2. FINAL PRESSURES ARE STILL TBD
3. OPERATED BY HAND PADDLE INITIALLY: USE LABELS THAT SAY "VALVE", NOT "CLAMP". USE ALL BLACK KNOBS, NOT GREEN OR RED.
4. DE-STA-CO SWITCH. SEE D0931, TC810151, 6 PLACES
INCHES
N.A.
KECK/DEIMOS
GRATING SUPPORT
VALVE SEQUENCING
j.o. 9 19 00
D4102.K
G 5 10 01 j.o. ADD SLIDER 5 PER ECO 42401
H 7 3 01 j.o. NEW CLAMP PER ECO 62101
J 12 19 01 j.o. ADD DRAWING CALLOUTS.
K 6/28/02 VRW ADD NEXT ASSY, CHG CALLOUT
A 9 19 00 j.o. RE-NAME DWG. WAS CONE FOR OLD MODEL.
B 12 15 00 j.o. DURING PLUMBING CHECKOUT, SLIDER 2
C 12 18 00 j.o. CHANGE PRESSURES. MINOR REVS.
D 1 18 01 j.o. SEQUENCE ESTABLISHED. LIMITS NOTE.
E 1 19 01 j.o. ADD NOTES
F 3 28 01 j.o. MODIFY PER ECO 32601.

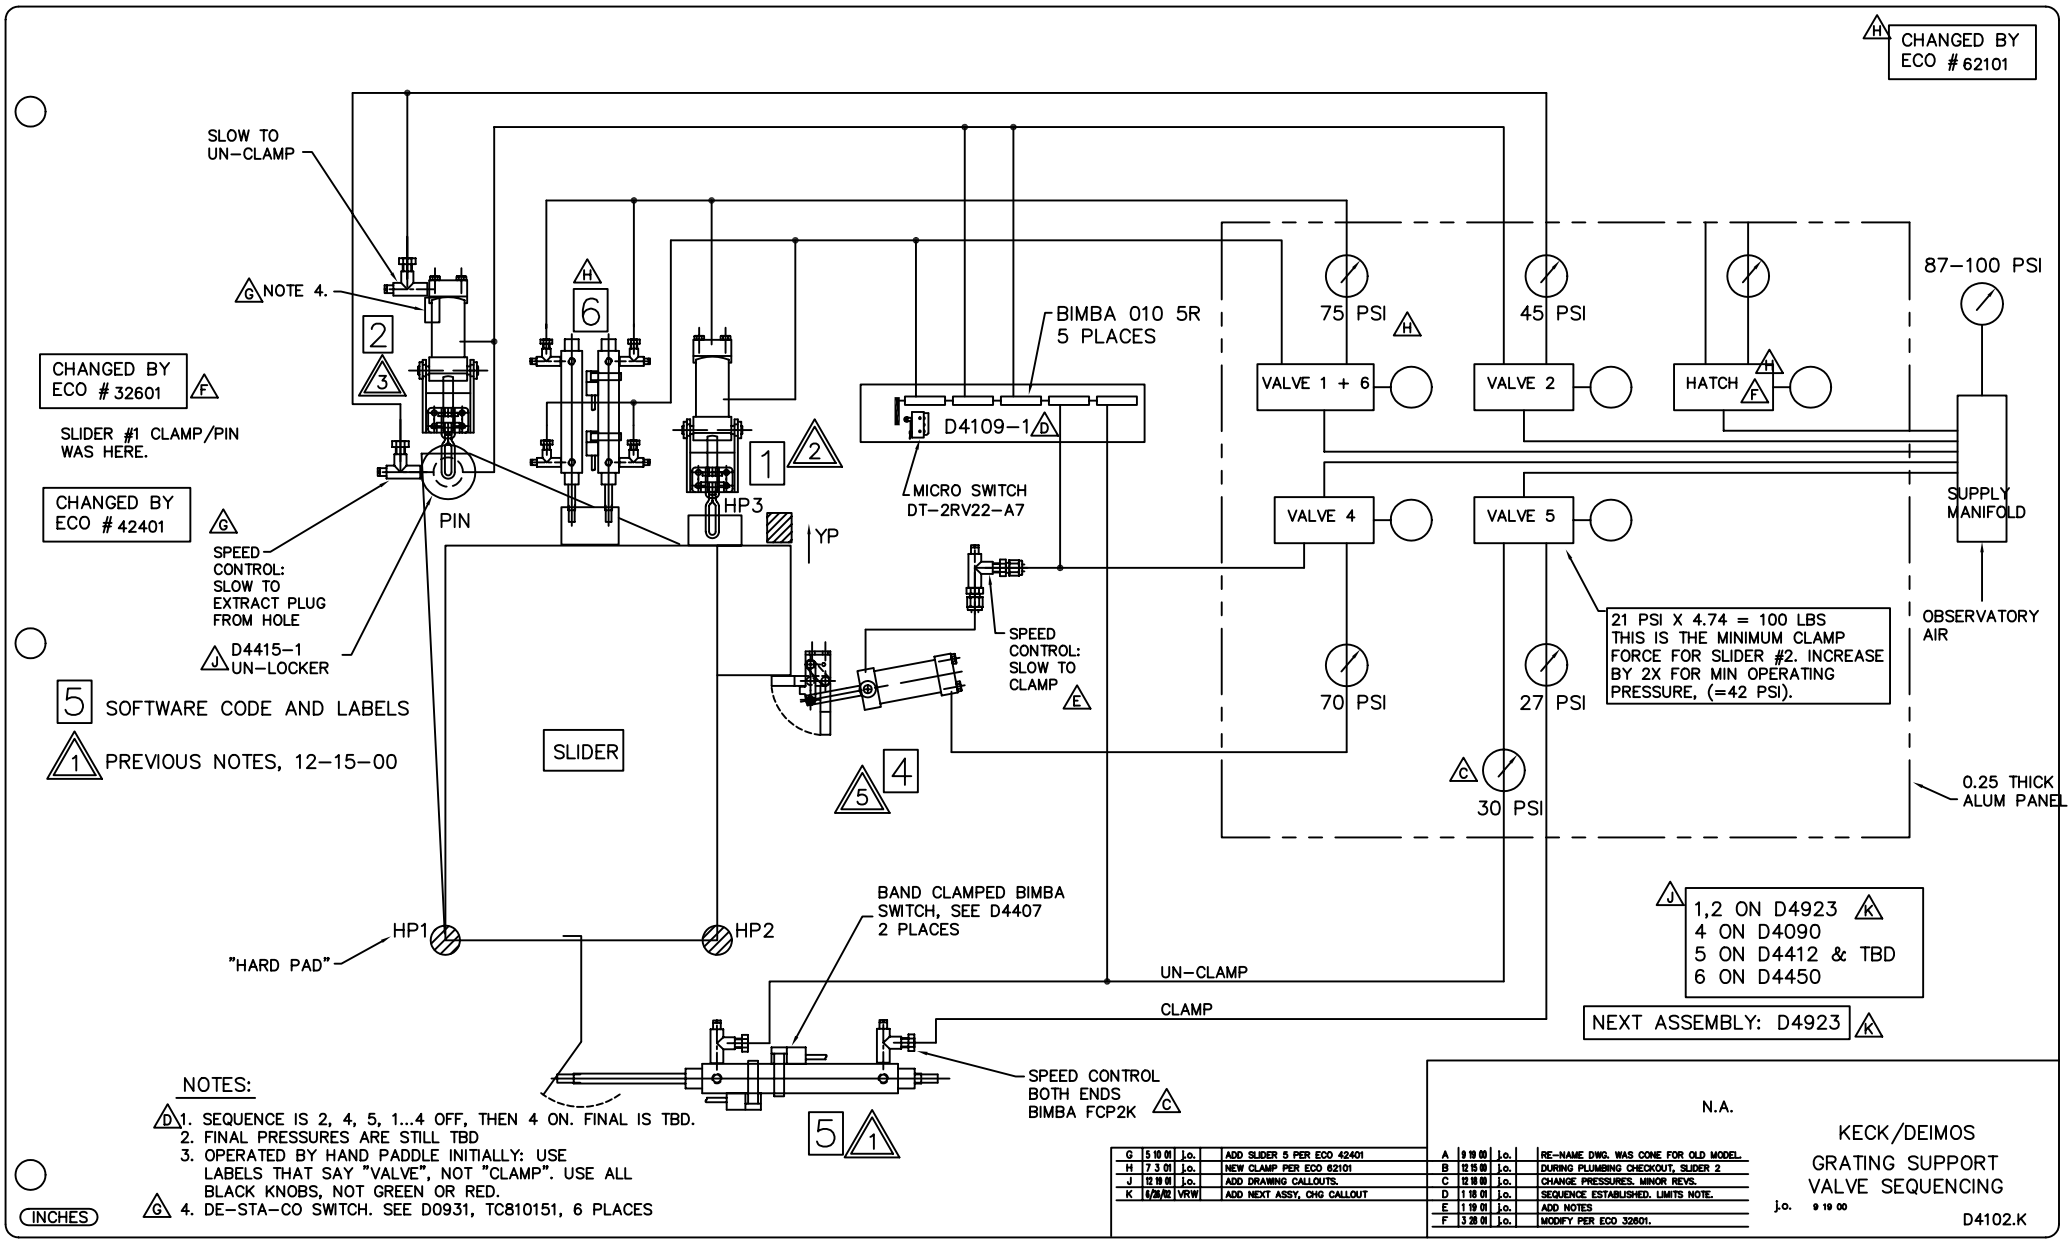
CHANGED BY ECO # 62101
SLOW TO UN-CLAMP
NOTE 4.
CHANGED BY ECO # 32601
SLIDER #1 CLAMP/PIN WAS HERE.
CHANGED BY ECO # 42401
SPEED CONTROL: SLOW TO EXTRACT PLUG FROM HOLE
D4415-1 UN-LOCKER
PIN
HP3
YP
SLIDER
HP1
HP2
"HARD PAD"
BIMBA 010 5R 5 PLACES
D4109-1
MICRO SWITCH DT-2RV22-A7
SPEED CONTROL: SLOW TO CLAMP
BAND CLAMPED BIMBA SWITCH, SEE D4407 2 PLACES
UN-CLAMP
CLAMP
SPEED CONTROL BOTH ENDS BIMBA FCP2K
75 PSI
45 PSI
87-100 PSI
VALVE 1 + 6
VALVE 2
HATCH
VALVE 4
VALVE 5
SUPPLY MANIFOLD
OBSERVATORY AIR
21 PSI X 4.74 = 100 LBS THIS IS THE MINIMUM CLAMP FORCE FOR SLIDER #2. INCREASE BY 2X FOR MIN OPERATING PRESSURE, (=42 PSI).
70 PSI
27 PSI
30 PSI
